# Access Compliance Report

## Public Rights-of-Way

Intersection ID: 27977	Main Street: EDINDALE_DR	Cross Street: HAWICK_VALLEY_LN	Location: NE
ADA ID: 304F0A84A377	Ramp Type: PerpDiag	Initial Pass/Fail: Fail	Overall Compliance: No
		Severity Score: 25

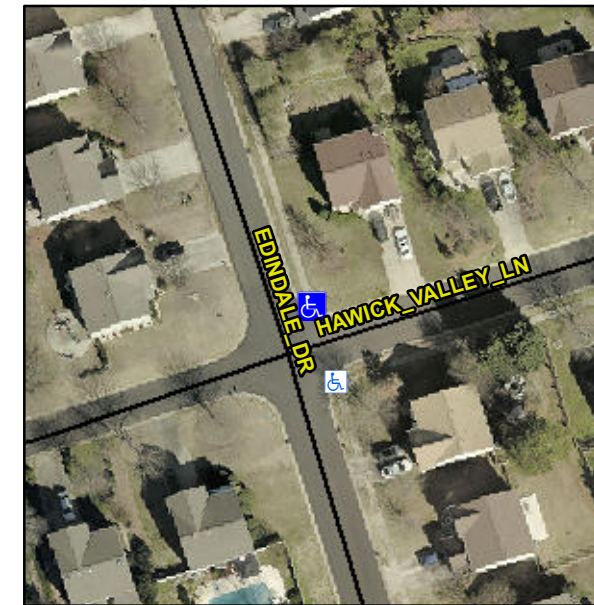
**R304.2.2, R304.5.3**

Compliance	Description	Data	Compliance	Description	Data
N/A	Ramp Length (in)	47.0	No	Ramp Slope (%)	8.5
Yes	Ramp Width (in)	102.0	No	Ramp XSlope (%)	6.5
N/A	Flare Type LT	N/A	N/A	Flare Type RT	N/A
N/A	Flare Slope LT (%)	N/A	N/A	Flare Slope RT (%)	N/A
N/A	Flare Traversable LT?	N/A	N/A	Flare Traversable RT?	N/A
N/A	Landing Length (in)	N/A	N/A	DWS Provided?	N/A
N/A	Landing Width (in)	N/A	N/A	DWS Contrast?	N/A
N/A	Landing Slope (%)	N/A	N/A	DWS Length (in)	N/A
N/A	Landing X Slope (%)	N/A	N/A	DWS Full Width?	N/A
N/A	Landing Curb? (Y/N)	N/A	N/A	DWS Offset (in)	N/A
N/A	Shared Landing?	N/A			
N/A	Gutter Ponding?	N/A	N/A	Gutter Slope (%)	N/A
N/A	Gutter Lip Ht (in)	N/A	N/A	Gutter X Slope (%)	N/A
N/A	Painted X Walk1?	No	N/A	Painted X Walk2?	No
	X Walk 1 Direction	To W		X Walk 2 Direction	To S
N/A	X Walk 1 Width (in)	N/A	N/A	X Walk 2 Width (in)	N/A
	X Walk 1 Slope (%)	1.9		X Walk 2 Slope (%)	3.2
	X Walk 1 X Slope (%)	3.7		X Walk 2 X Slope (%)	0.7

**Remove & Replace Curb Ramp With Two New Directional Ramps or Equivalent.**
